LA FIRE SPRINKLER ASSOCIATION QUARTERLY MEETING  
APRIL 20, 2005  
SFM ITEMS OF CONCERN

1 2002 NFPA 13: 8.14.1.2.3 SPRINKLER PROTECTION OF COMBUSTIBLE CONCEALED SPACES WITH LESS THAN 6" BETWEEN OPPOSITE FACES IN CAVITY.

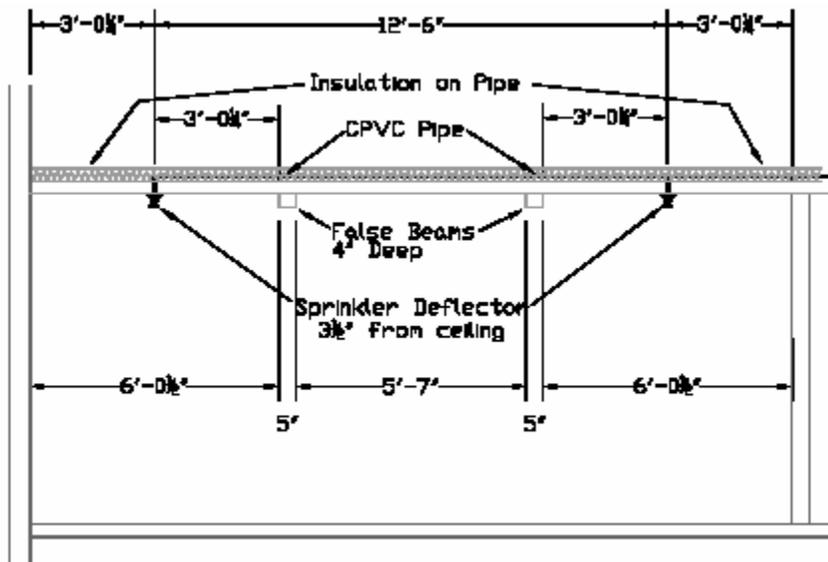
Please be advised that this office takes guidance from NFPA 13: 8.14.1.2.3, 2002 edition. If a combustibile concealed space has a dimension of less than 6" between opposite faces of construction within the cavity, then sprinklers are not required.

As an example, regarding the 4" x 4" false beams in the following detail, sprinkler protection is not required. Because the opposite faces are less than 6", filling the cavity with non-combustibile insulation per NFPA 13:8.14.1.2.7, is also not required.

6 2002 NFPA 13: WATER SUPPLY REQUIREMENTS FOR ROOM DESIGN METHOD.  
11.2.3.3

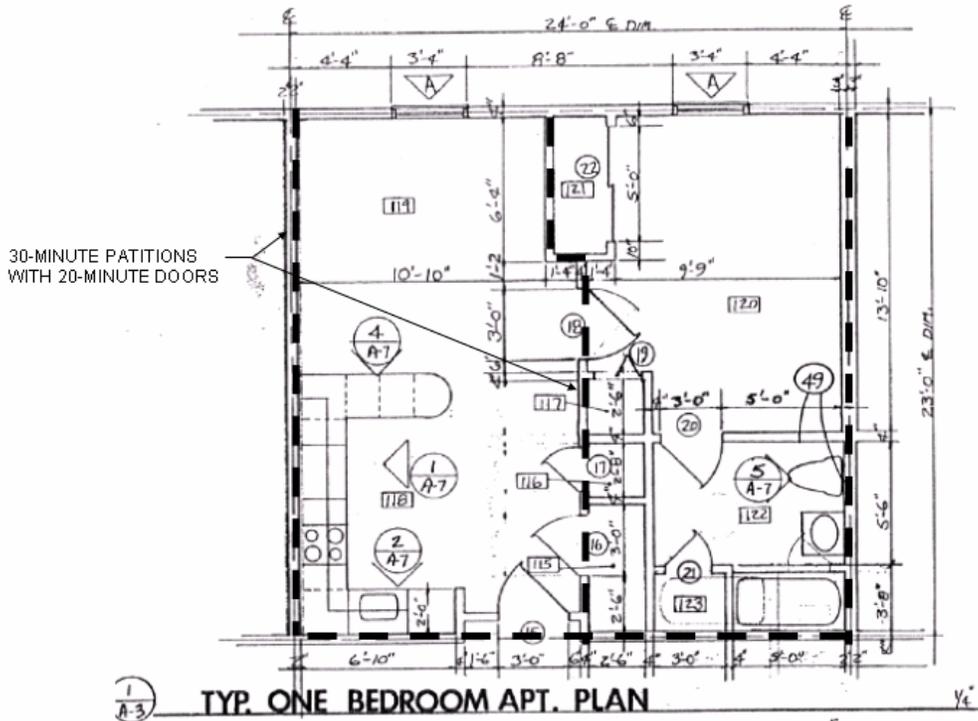
Utilizing 11.2.3.3.4, If the room is smaller than 1500 sf then 11.2.3.1.8 1 or 2 shall apply. This would mean only calculating the "Kitchen Area (Room 118 & 119)" in our attached room layout. Is this correct?

Calculating the kitchen/living area would be the most hydraulically demanding "large room", provided all partitions in the entire building, are rated a minimum of 30 minutes, and the kitchen/living area shown on attachment was the largest room with the most heads. All room compartments must satisfy the 30-minute fire resistance requirement. With 30 minute walls, refer to NFPA 101:8.3.4 - all doors must have a minimum 20-minute rating and must be self closing, per 101:Table 8.3.4.2.

However, if only "some" of the partitions in the building meet the minimum 30-minute requirement, then you must investigate for the hydraulically most demanding area. At 61 sq. ft., the bathroom requires sprinkler protection, per NFPA 13:8.14.8.1.1. It appears that all closets are less than 24 sq. ft., meet all requirements of NFPA 13:8.14.8.2, and do not need sprinkler protection in each.

For example purposes only, I placed a dashed line on your sample plan (see above). The dashed lines represent 30-minute fire barriers. The unmarked, remaining partitions do not meet the minimum 30-minute requirement. In other words, the bedroom, bathroom and all five closets now become one large communicating space, and must be acknowledged as "one room" when using the room design method. In this case, both the bedroom and bathroom would be "communicating", meeting the intent of NFPA 13:A.11.2.3.3.1.

Another example: say all partitions throughout building can be verified as 30-minute rated, but the doors from living area to bedroom and bedroom to bathroom are not minimum 20-minute rated. If this is the case, then the entire residential unit has to be acknowledged as "one room" when using room design method. In this case, all three rooms would be "communicating", meeting the intent of NFPA 13:A.11.2.3.3.1.
